UNITED STATES
NUCLEAR REGULATORY COMMISSION
REGION II
101 MARIETTA STREET, N.W.
ATLANTA, GEORGIA 30323

Report Nos.: 50-335/85-31 and 50-389/85-31

Facility Name: St. Lucie 1 and 2

Inspection Conducted: December 2-6, 1985

FIGURE 1

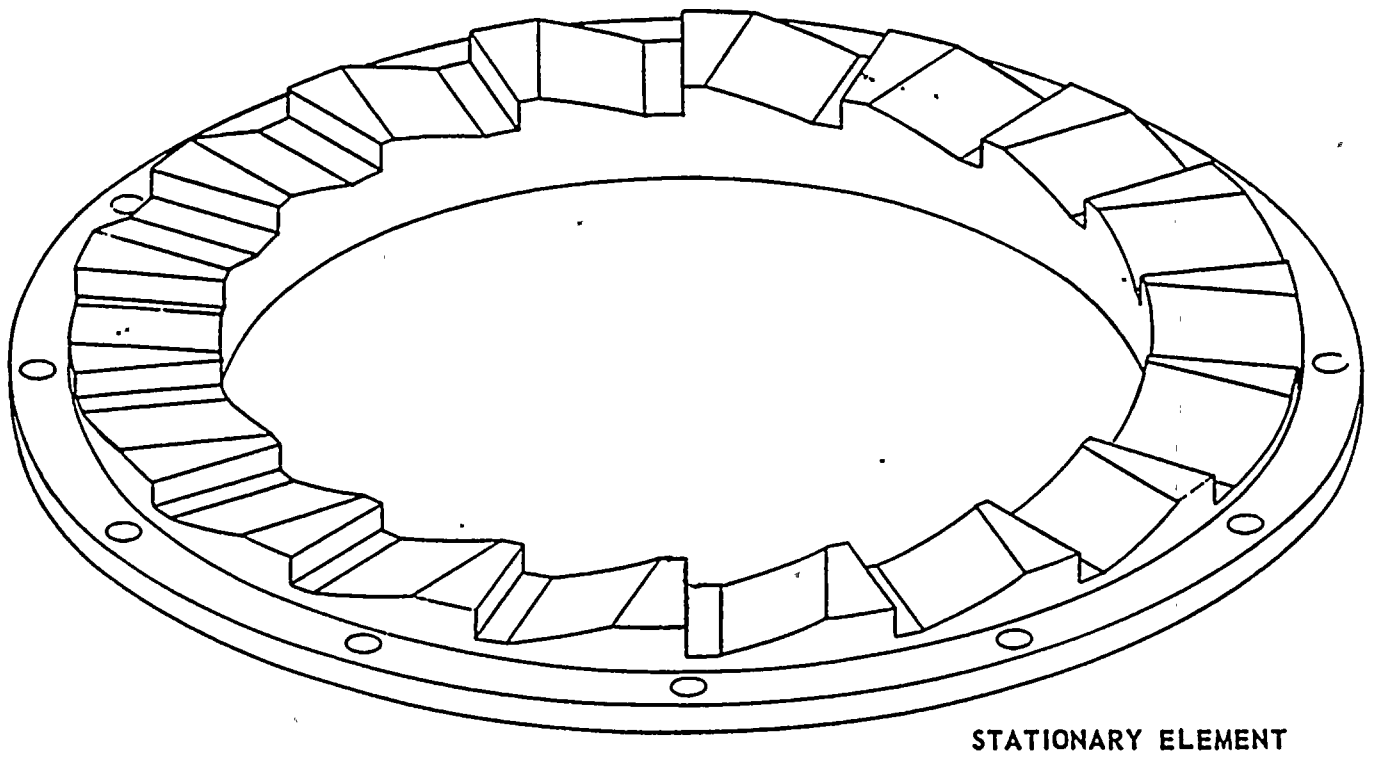
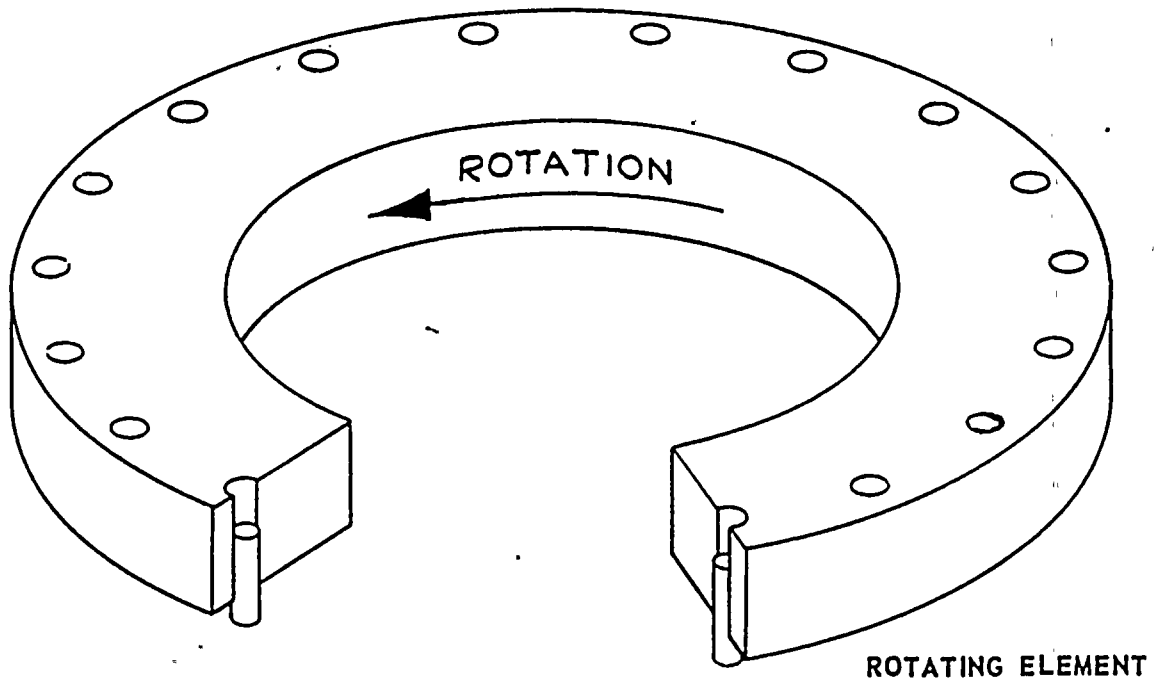
The Anti-Reverse Rotation Device (ARRD) on each Allis-Chalmers Reactor Coolant Pump (RCP) motor consists of a stationary ratchet element bolted to the motor frame, and a rotating element keyed to the motor shaft with thirty-six anti-rotational pins and pin retainers. At speeds of less than 100 rpm in the forward direction the pins contact the stationary element and ride up the ramps. At approximately 100 rpm the ramps push the pins into the retainers in the rotating element where centrifugal force will hold them until the RCP speed slows to below 100 rpm. As the RCP coasts down the pins fall and ride along the ramps. When the RCP stops, the pins contact the vertical backstops preventing reverse-rotation. The pins are $1\frac{1}{2}$ inches in diameter and about 5 inches long. They are chromium-molybdenum with a molybdenum sulphide (Fearlon) tip to reduce wear on the stationary element. Refer to figure 1.

During repair of a Unit 2 RCP in September 1985, several of the pins were found to be lodged in the pin retainers. Further investigation revealed that many pins in the other Unit 2 RCP's were lodged in their retainers and many of the pins that fell freely had broken Fearlon tips or other surface defects. The edges of the pins, which lodged in the retainers, had mushroomed out due to metal to metal contact with the stationary element such that they could no longer fall by gravity. The Unit 1 ARRD's were inspected during the present refueling outage and similarly damaged pins were discovered. A summary of the pin damage is shown in Table 1.
